MEETING AGENDA OF THE CLEARFIELD CITY PLANNING COMMISSION

1. Discussion and Possible Action on **SP 2019-110019**, a site plan proposal by Davis County for a 13,890 square foot library at the subject property. **Location:** 1 North Main Street (TIN: 12-930-0003). Parcel Area: 1.5 Acres. Zone: CV (Civic). **Planner:** Brad McIlrath (**Administrative Action**).

SUBJECT: Discussion and Possible Action on **SP 2019-110019**, a site plan proposal by Davis County for a 13,890 square foot library at the subject property. **Location:** 1 North Main Street (TIN: 12-930-0003). Parcel Area: 1.5 Acres. Zone: CV (Civic). **Planner:** Brad McIlrath (**Administrative Action**).

Attn: Brad McIlrath, Senior Planner
Proj: **Davis County North Branch Library**
Subj: Review #1

AS101

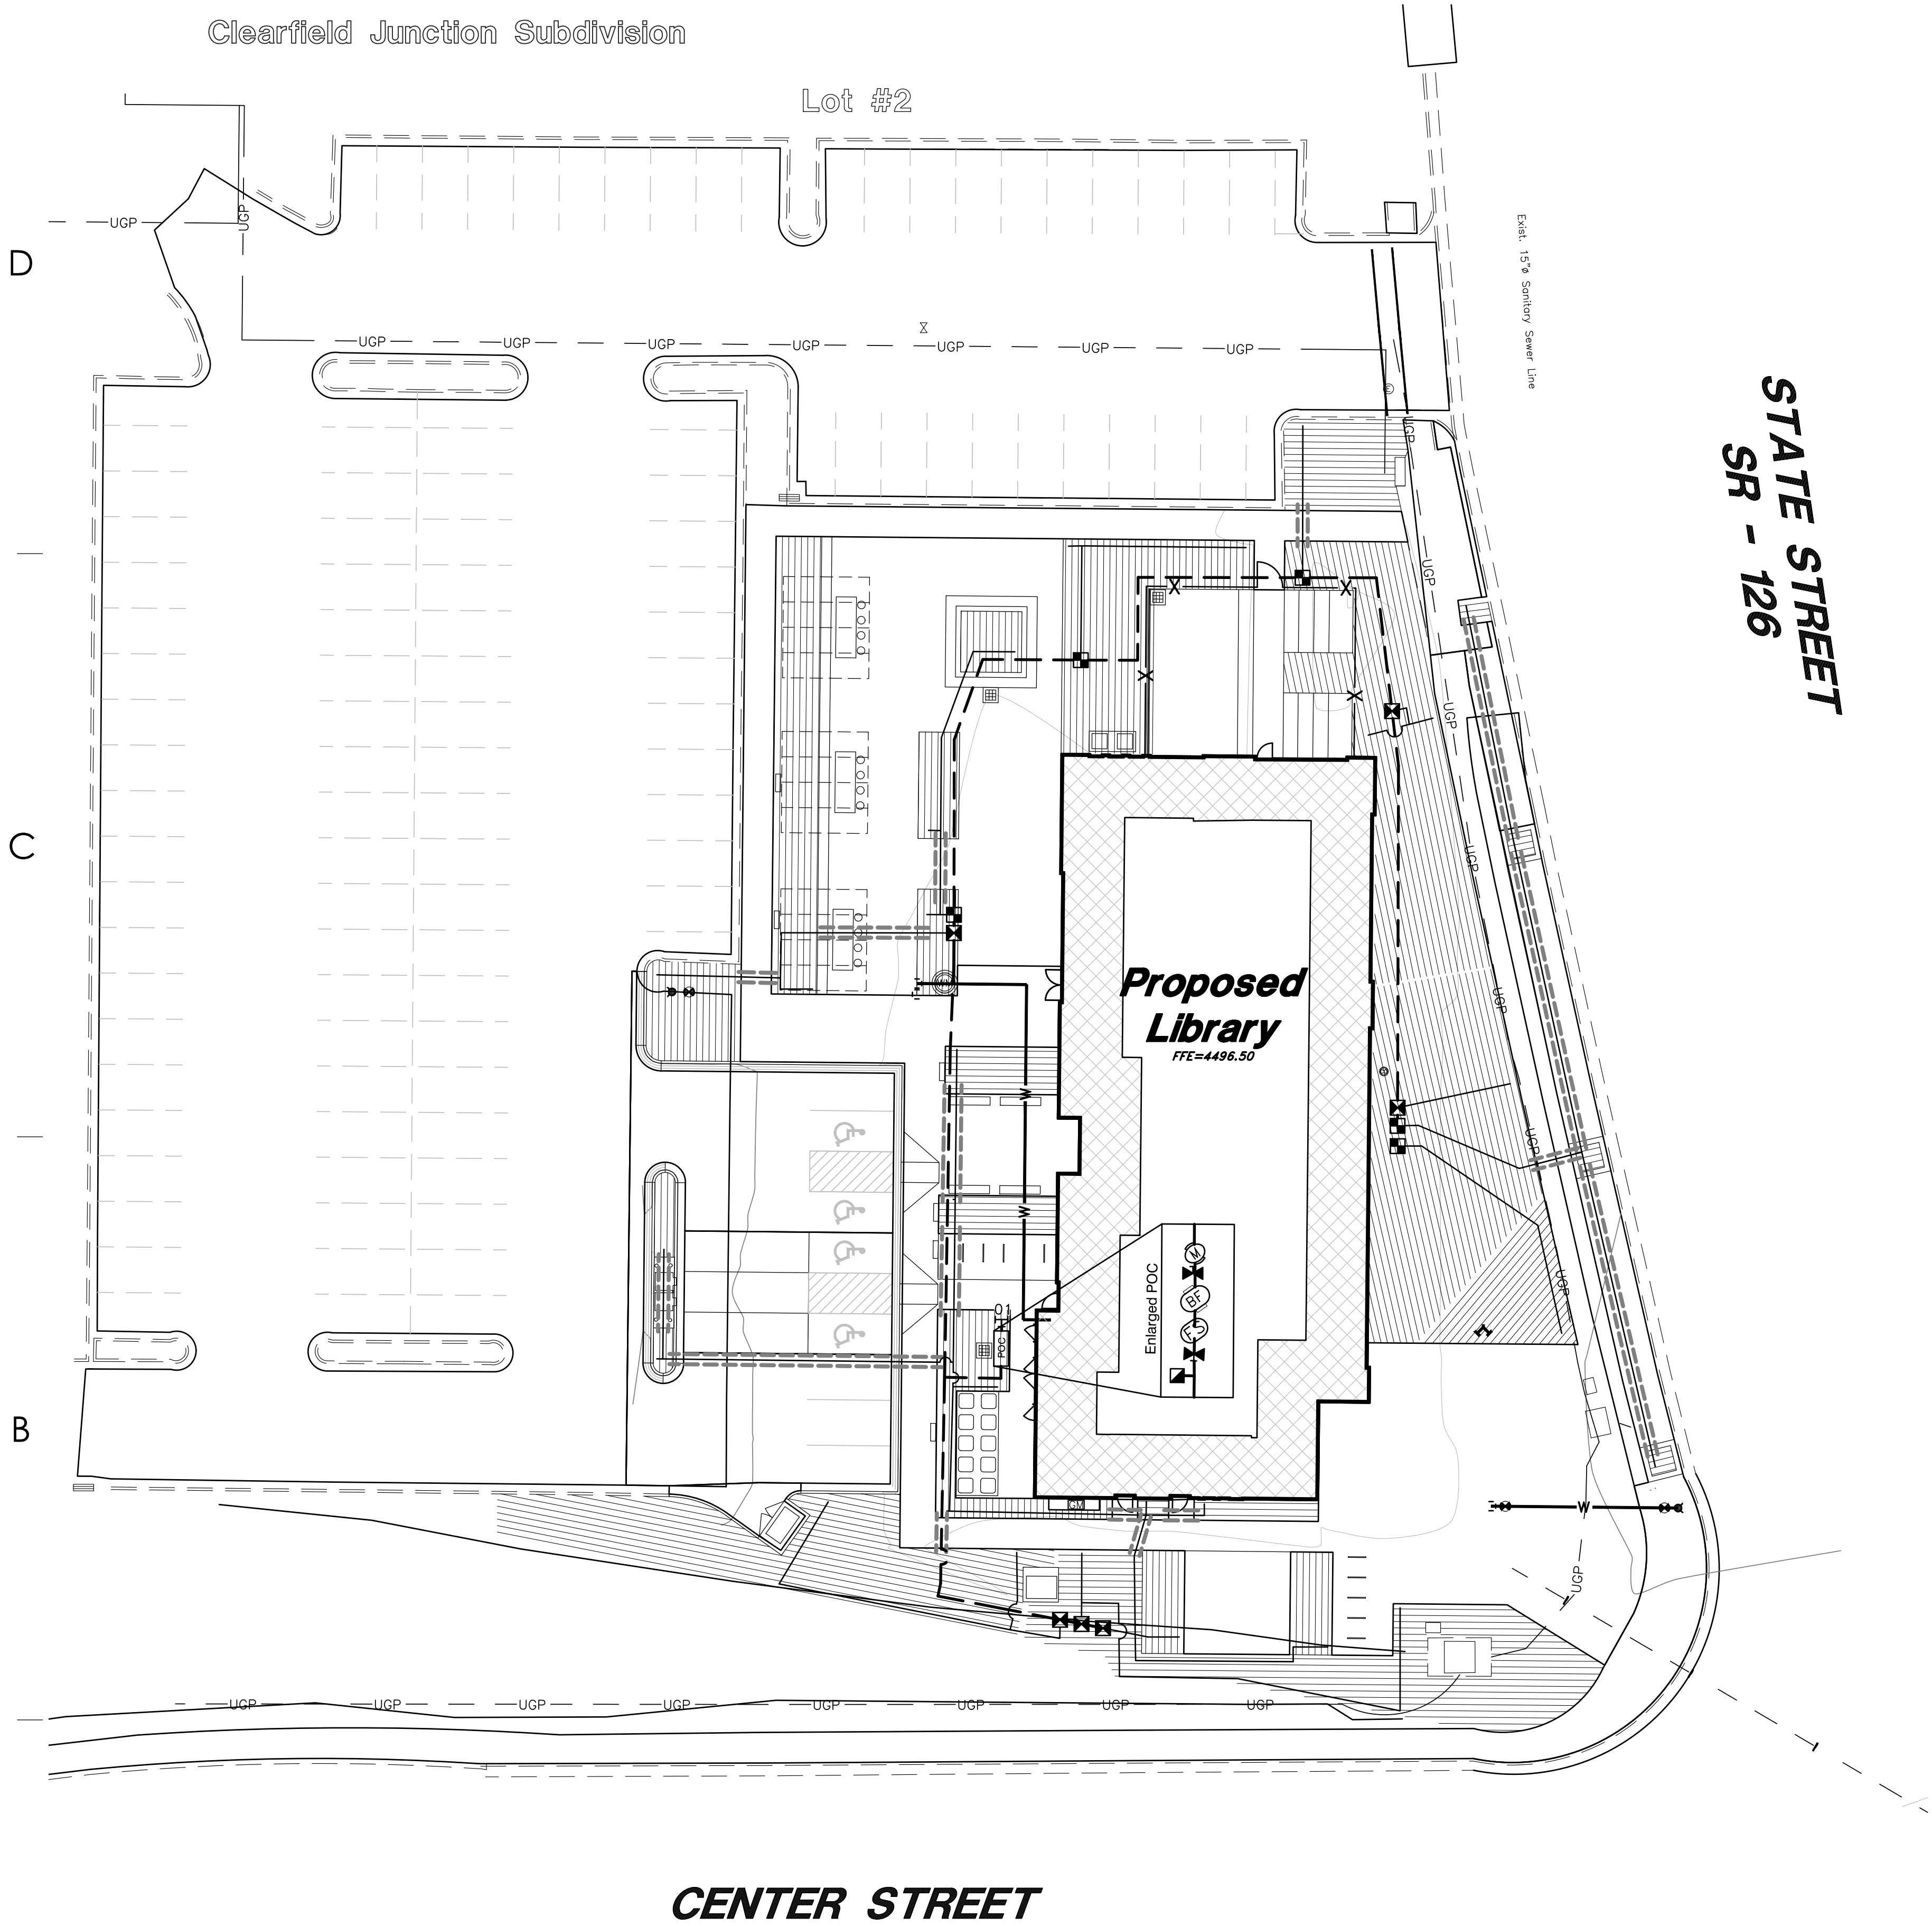
Street lighting along State Street must be double acorn lights spaced to match the existing spacing of lights along the corridor.	Non-Compliance with FBC <u>Staff Note:</u> The plans do not include street lighting within the furnishing zone. The site plan and landscaping plans will need to be revised to show the location of the street lights with spacing between sixty (60) and ninety (90) feet on center.

- 2) Double acorn street lights shall be installed along the Main Street frontage meeting the design standards for the type, distance, and locations as required by code.

LP101

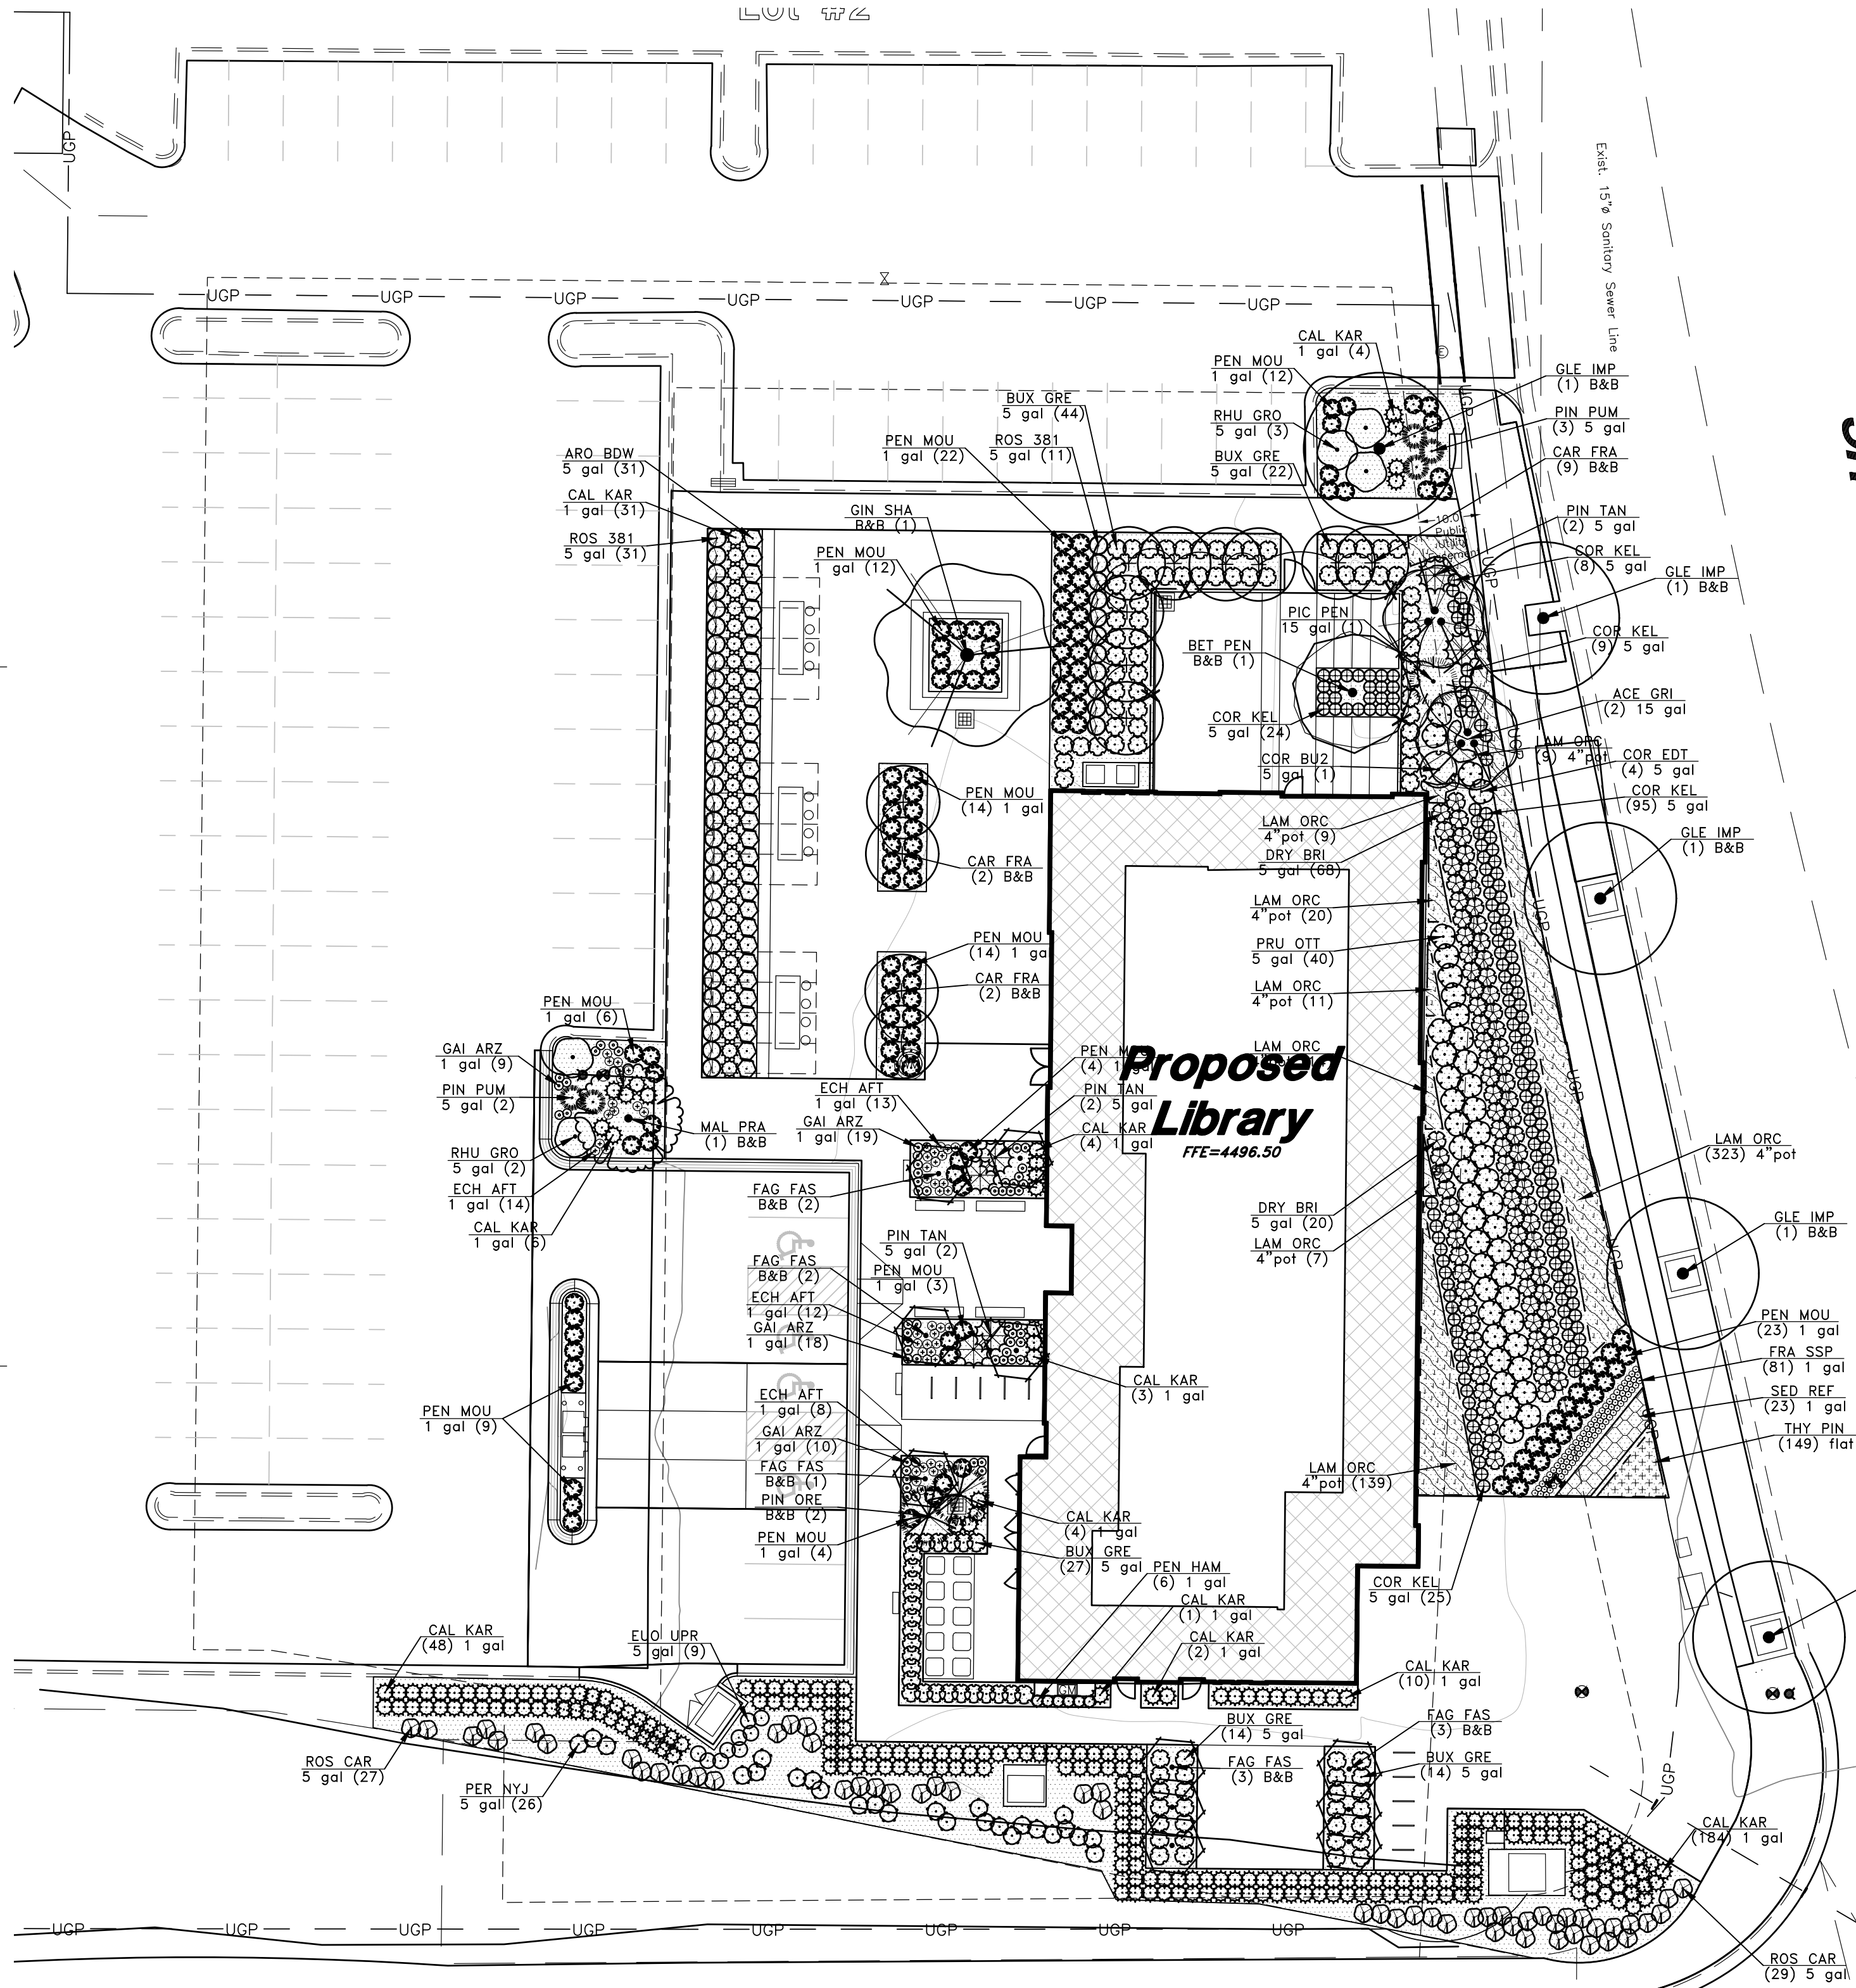
Standard:	Staff Analysis:
a) 20 trees are required per 1 acre of project. Street trees do not count toward this requirement.	Complies with FBC <u>Staff Note:</u> With a development acreage of 1.5 acres, a total of 30 trees are required. The landscape plan shows a combination of 37 different trees.

- The landscaping design and improvement will need to be extended to the south curb & gutter along Center Street (on the hillside slope). The landscaping design must consider the appropriate landscaping for the hillside slope.
- A note will need to be placed upon the "Site Plan" drawings that all landscaping must be maintained by the property owner (beginning at the curb & gutter and extending back into the property).
- Show on the "Site Plan" drawing the location for the irrigation water connection – using a "reduced pressure" backflow device. A detail of the backflow device will need to be shown in the detail drawings.
